Meeting Notes

Project 2007-06 System Protection Coordination Standard Drafting Team

1. **Title:** Protection System Coordination for Performance During Faults
2. **Number:** PRC-027-1
3. **Purpose:** To coordinate Protection Systems for Interconnected ~~Facilities, such that those Protection Systems remove from service only those Elements required to isolate Faults, while meeting the system performance specified within requirements established in other approved NERC Reliability Standards~~Elements, such that the least number of power system Elements are isolated to clear Faults.
4. **Applicability:**
 - 4.1. **Functional Entities:**
 - 4.1.1 Transmission Owner
 - 4.1.2 Generator Owner
 - 4.1.3 Distribution Provider
 - 4.2 **Facilities:**

Figure 3

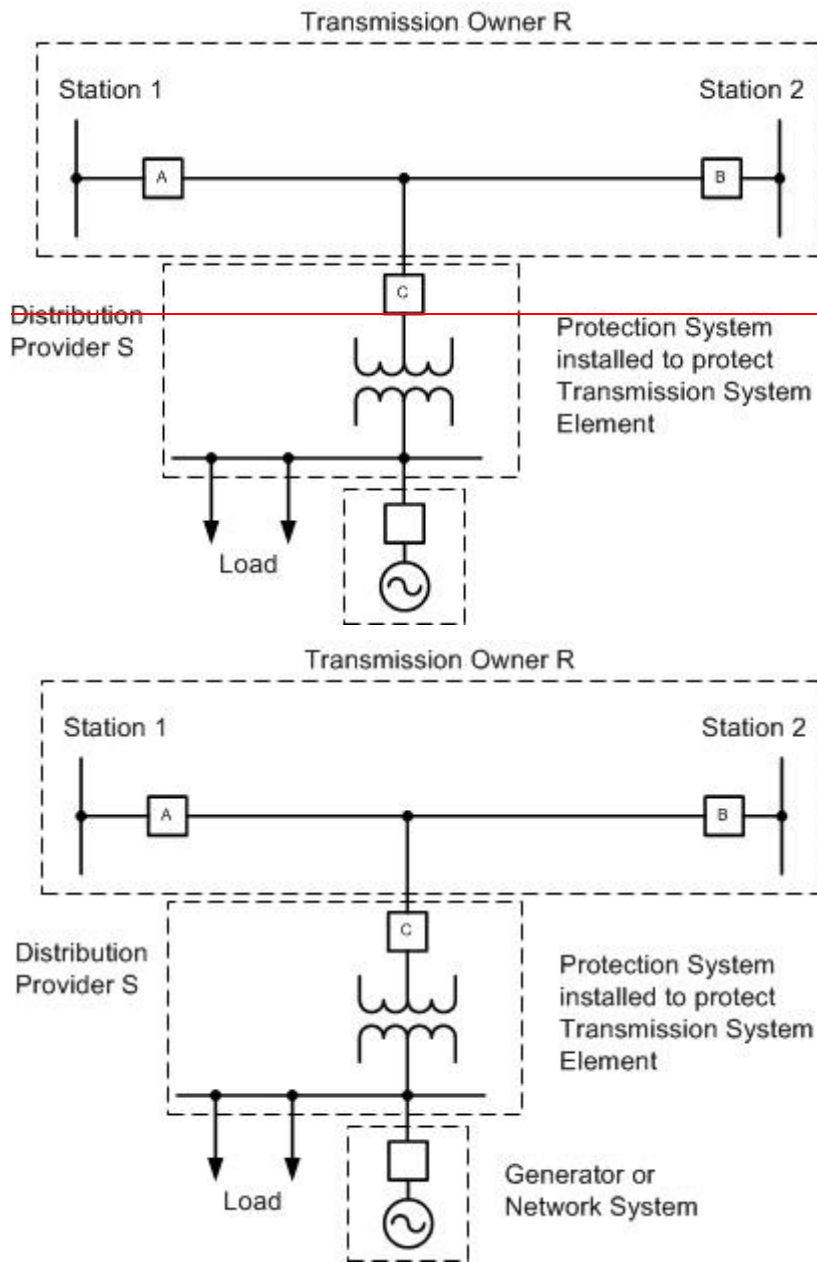
The drafting team revised the description relating to Figure 3 in the “Guidelines and Technical Basis” to clarify that only the Distribution Provider’s Protection Systems installed to protect for Faults on Transmission System Elements are a part of the Applicability of this standard. The drafting team modified Figure 3 to indicate that the source could be a generator or a network system.

In Figure 3 above, the ~~interconnecting-Interconnected~~ Element between the Transmission Owner ~~to and the~~ Distribution Provider ~~(with a generator)-Interconnected Facilities (Transmission Owner R line between Breakers A and B—Distribution Provider S)~~ is the transmission line or tap between the line and Breaker C.

Example: For the purposes of conducting the Protection System Study associated with the Facilities in Figure 3, ~~the responsibility for~~ Transmission Owner R is to ~~verify that review~~ the Protection System settings associated with Line Breaker C (provided by Distribution Provider S) ~~and the generator Protection Systems do not result in for~~ coordination issues with the Protection System settings associated with Breakers A and B and other Protection Systems at stations 1 and 2. ~~Likewise, the responsibility for Distribution Provider S is to verify that the Protection System~~
